ANN ARBOR HISTORIC DISTRICT COMMISSION

Staff Report

ADDRESS: 204 Koch Avenue, Application Number HDC19-181

Wedmeyer Addition at 204 Koch Avenue, Ann Arbor, MI RAA: 19-017

C2.0

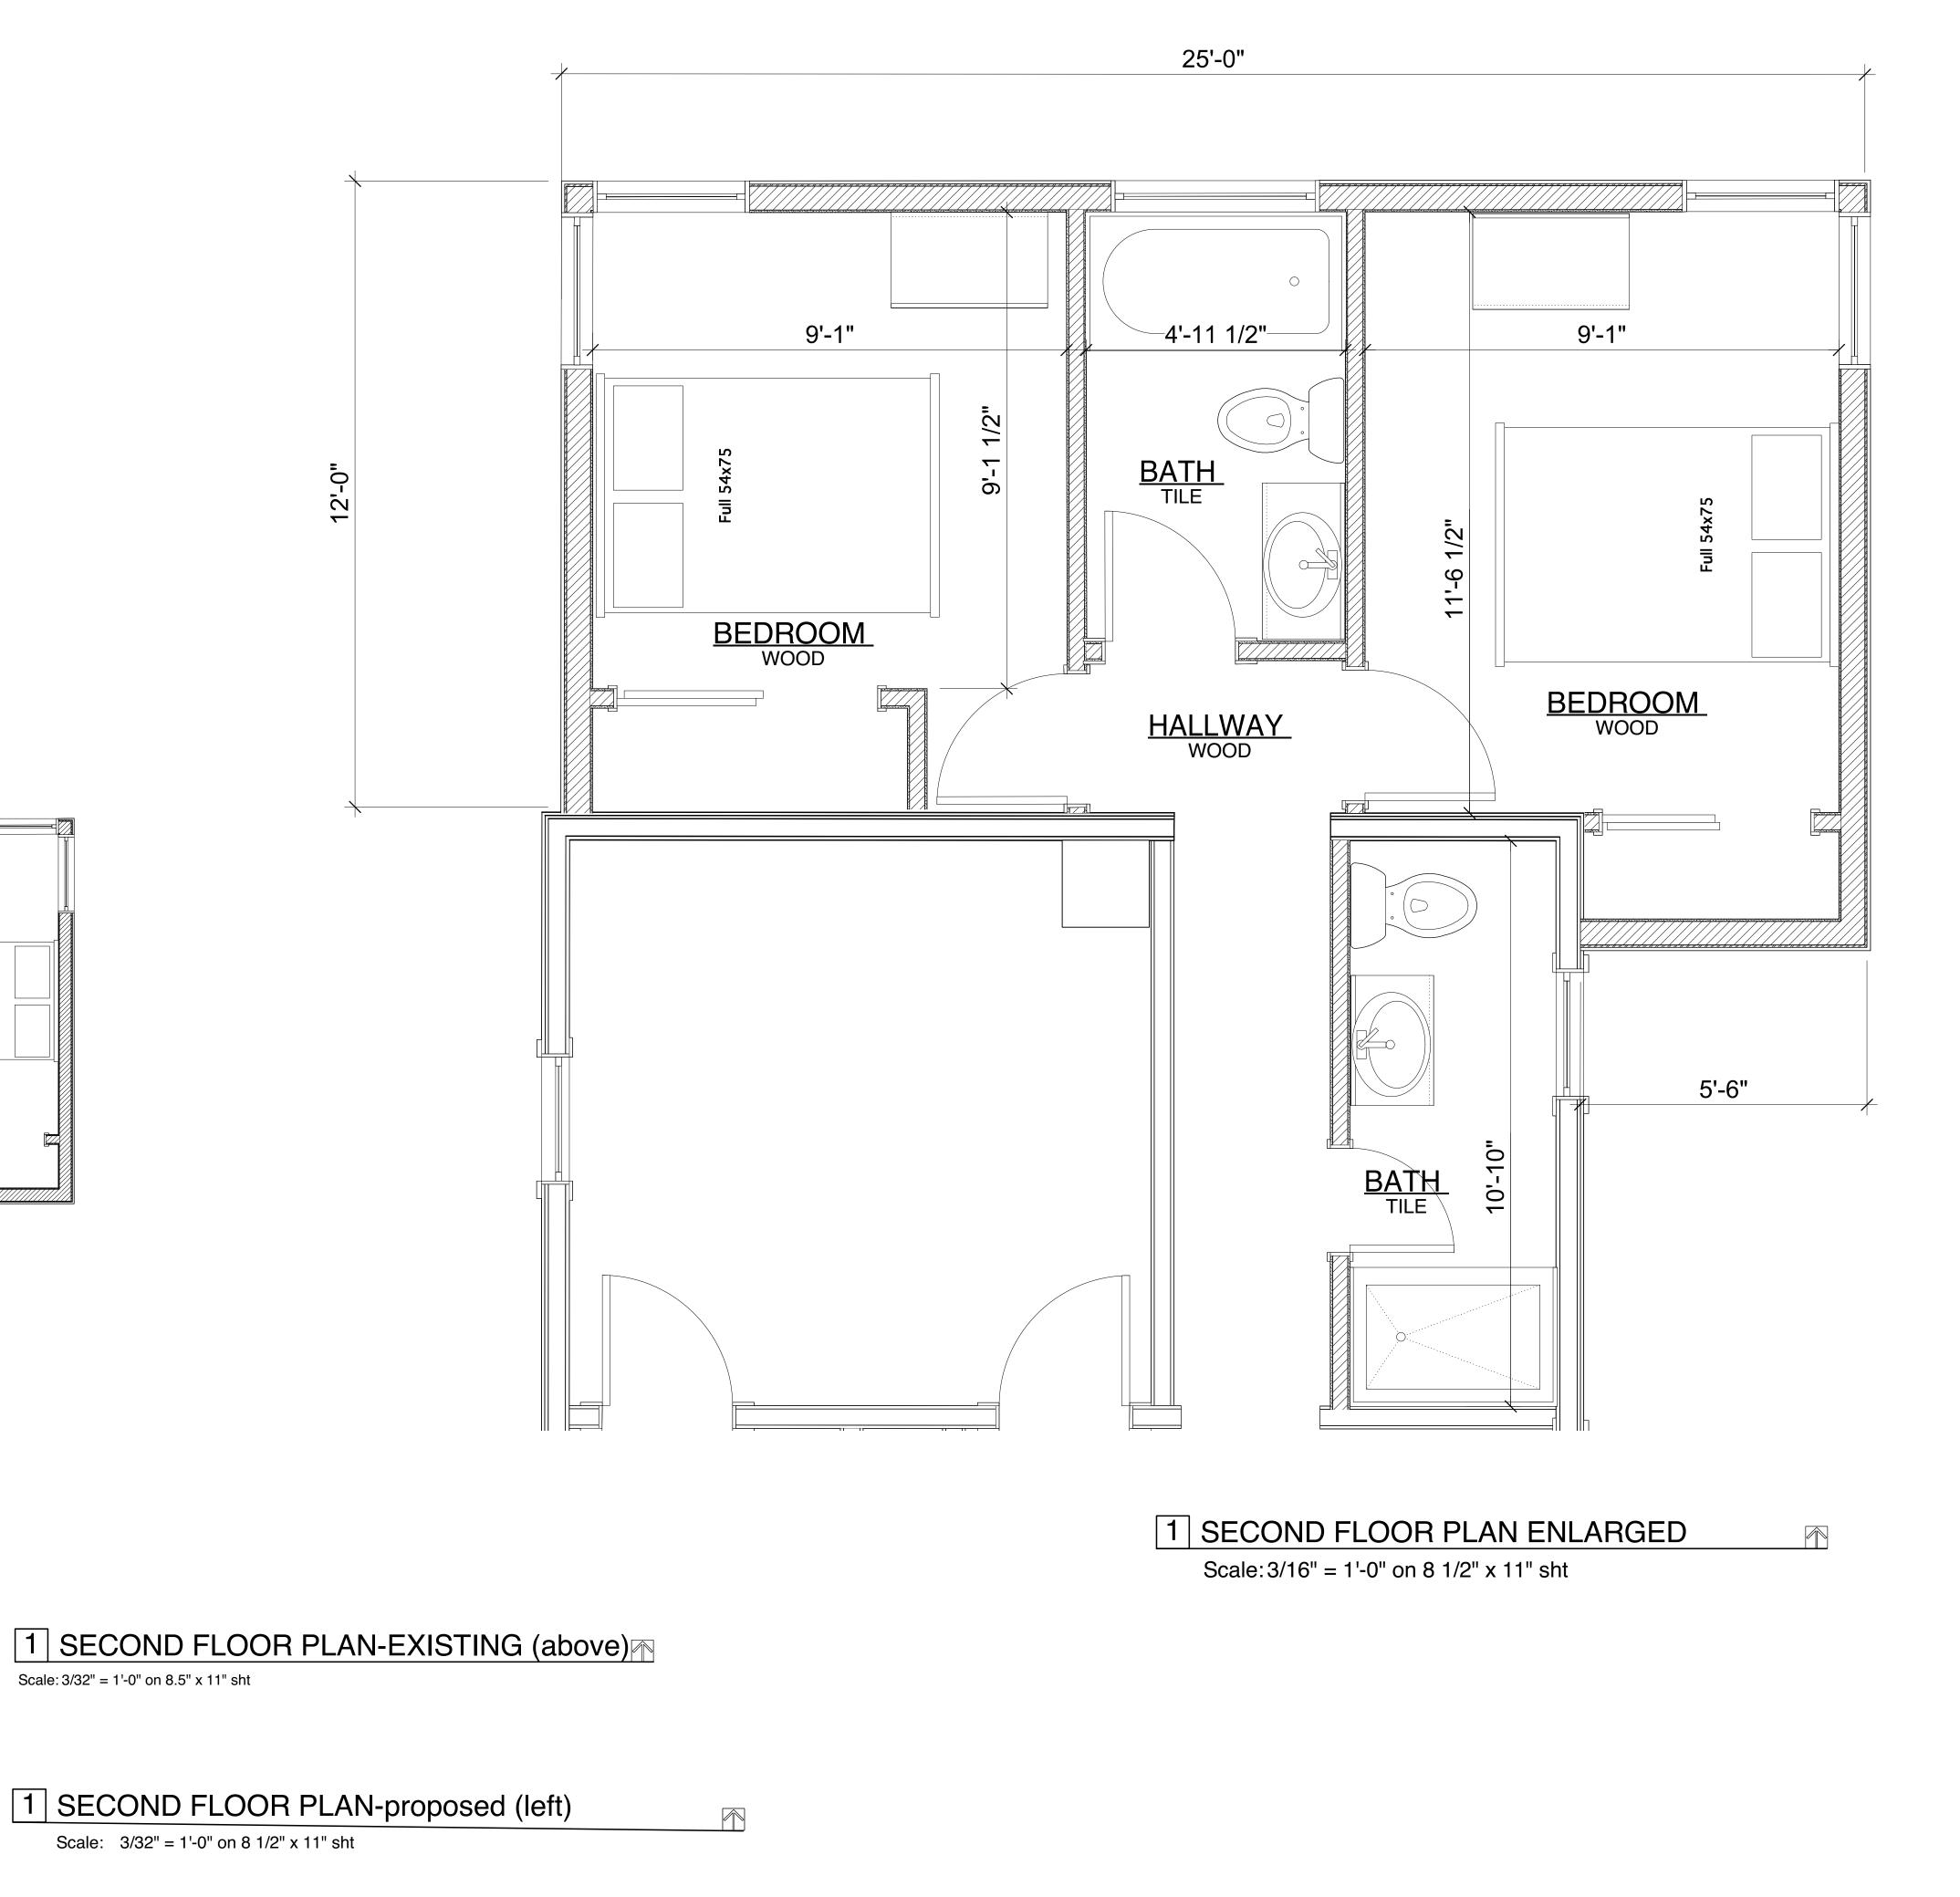
- 2. The resulting footprint of the additions (190 SF) would be 34% of the original footprint (560 SF), and the floor area of the additions (508 SF) to 45% of the original (1119 SF). This meets the Ann Arbor design guideline that says "The addition should exceed neither half of the original building's footprint nor half of the original building's total floor area".

- 5. This lot is a very small 3317 square feet. The rear addition already encroaches into the required rear setback, and a variance will be required from the zoning board of appeals for the proposed 24'2" rear setback (30' is required). Staff is concerned that the design deviates too much from the design guidelines. The new walls on the northeast corner are not subordinate to the historic fabric, and the second floor addition interferes with the historic character of the site, including historic relationships between the house, driveway, and garage.

1 WEST ELEVATION-PROPOSED

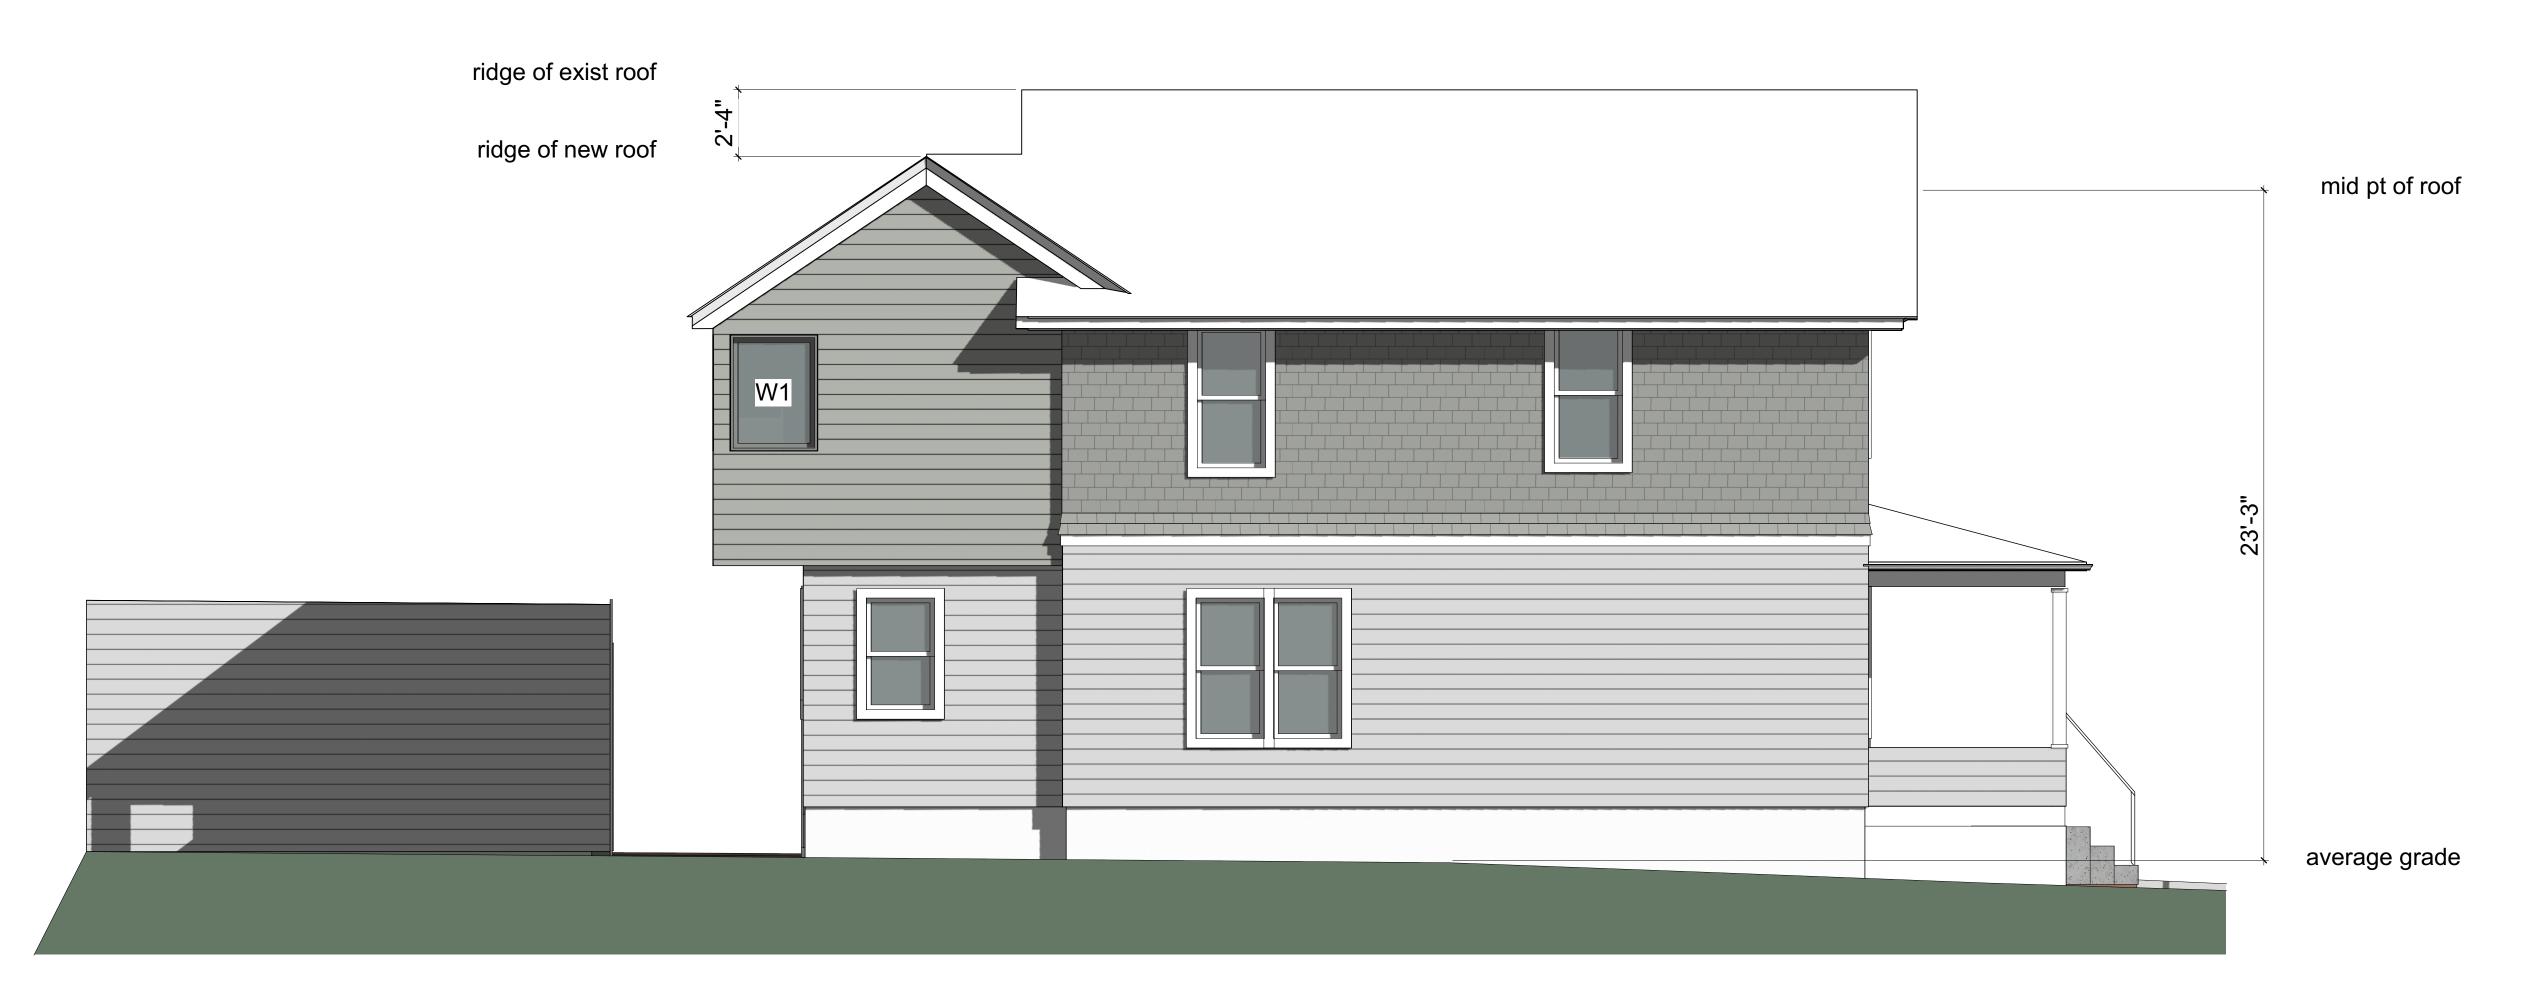
- 3. The addition preserves about 5" of the second floor corner of the house on the west side (dimension not indicated), which is very shallow but at least has a change in cladding and

rooflines from the house to the addition to help distinguish it. On the east (driveway) side, the first floor extends 2 ½' beyond the existing rear corner of the house, and the second floor extends 5' beyond the existing corner and wraps around it about 2 ½' toward the street. This is contrary to the Ann Arbor design guideline for residential additions that says to place "...new walls in a different plane from the historic structure, in a subordinate position to the historic fabric."
